Appendix D

Responses to Data Requests

In the Matter of the Application of Snowshoe BESS, LLC for a Site Permit for the up to 150 MW Snowshoe Energy Storage Project in Olmsted County, Minnesota

PUC Docket No. IP-7138/ESS-24-270

Figure 7

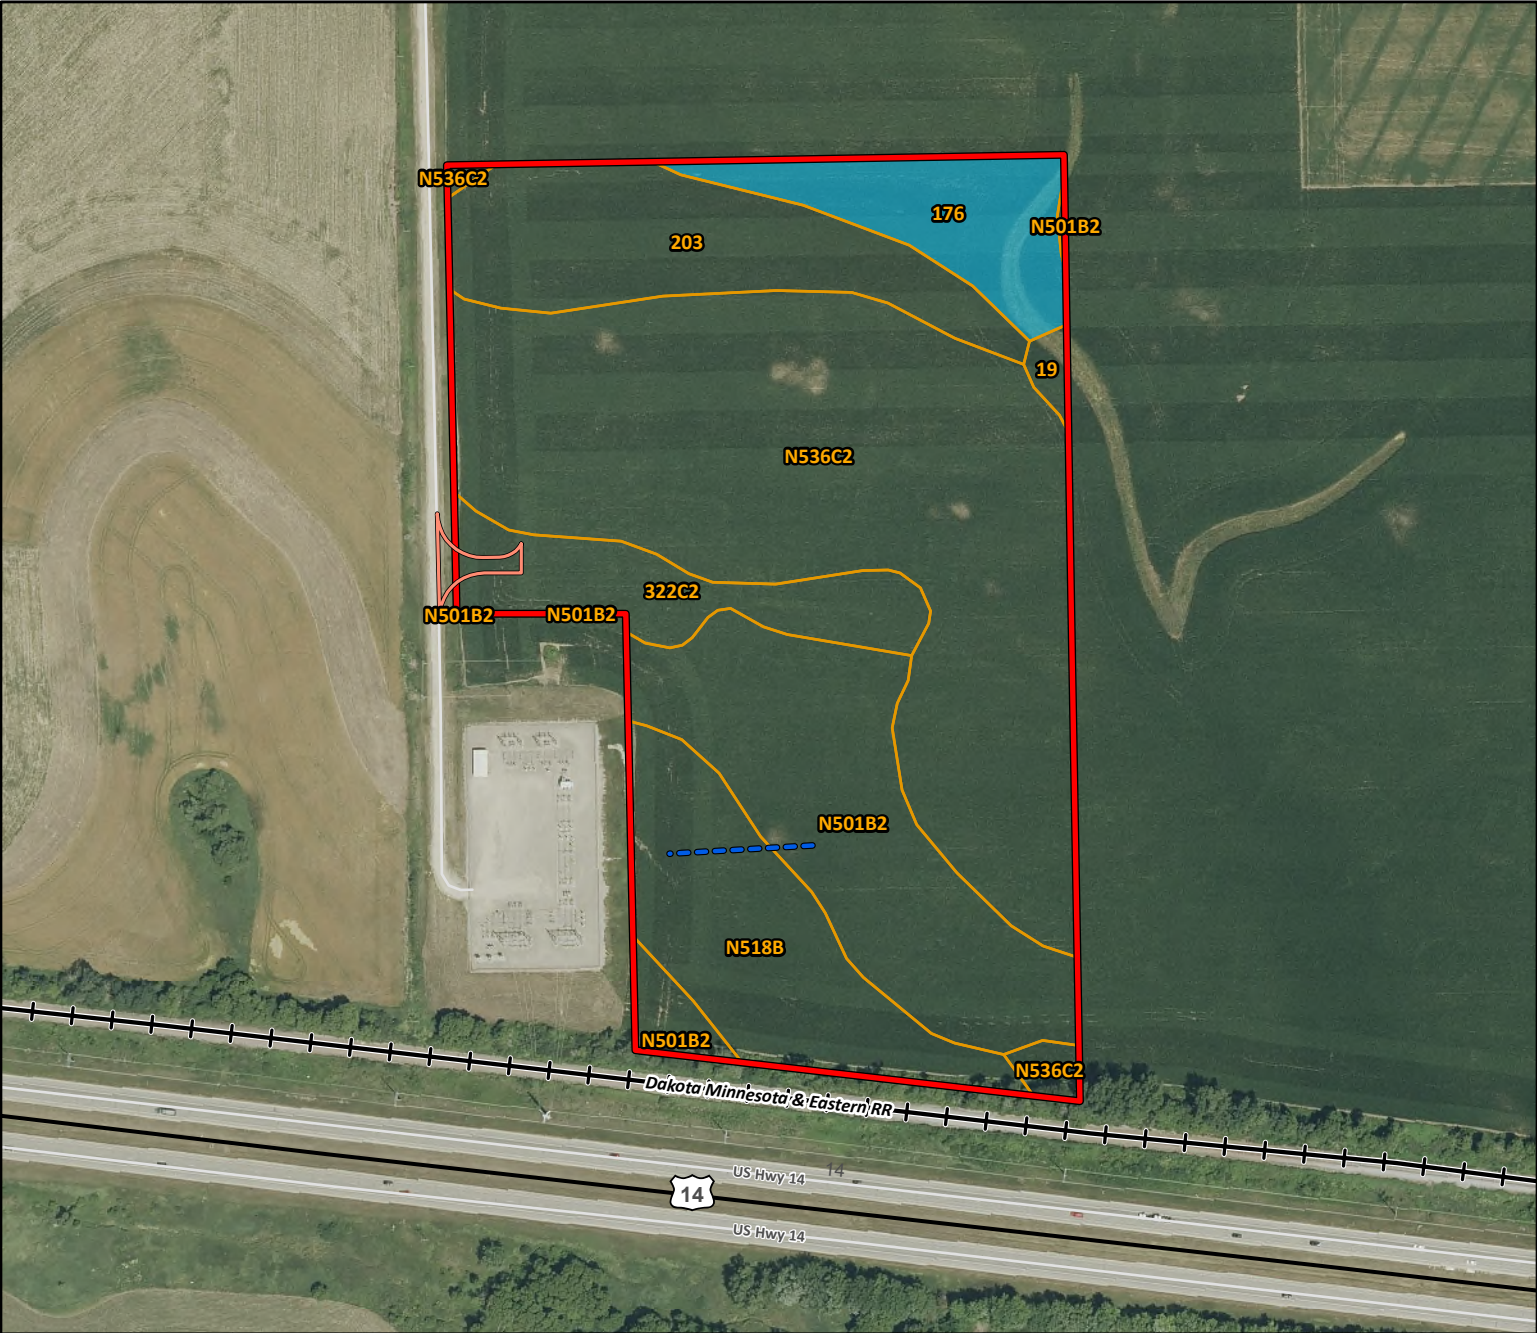
The soils identified at the Snowshoe site in the application (Table 5.5-4 and Figure 7) differ somewhat from those identified in EERA's site review at the NRCS soil survey

In particular, the NRCS map shows Tama Silt Loam (N536C2) in the area shown in application materials as Port Byron Silt Loam (285C) and Downs Silt Loam (N501B2) in the area shown in application material as Mt. Carrol Silt Loam ((401B).

Please review the source material and clarify the soil types. If applicable, please provide updates to Table 5.5-3 and Figure 7.

Snowshoe BESS, LLC created Figure 7 using soil data from the USDA Web Soil Survey (WSS). The USDA Natural Resources Conservation Service (NRCS) updated their soil database in October 2024 after Figure 7 was prepared and therefore the figure did not reflect the most recent updates to the database.

As requested, Snowshoe BESS, LLC revised Figure 7 and Table 5.5-4: Project Area Soils to reflect these recent changes made to the Web Soil Survey.
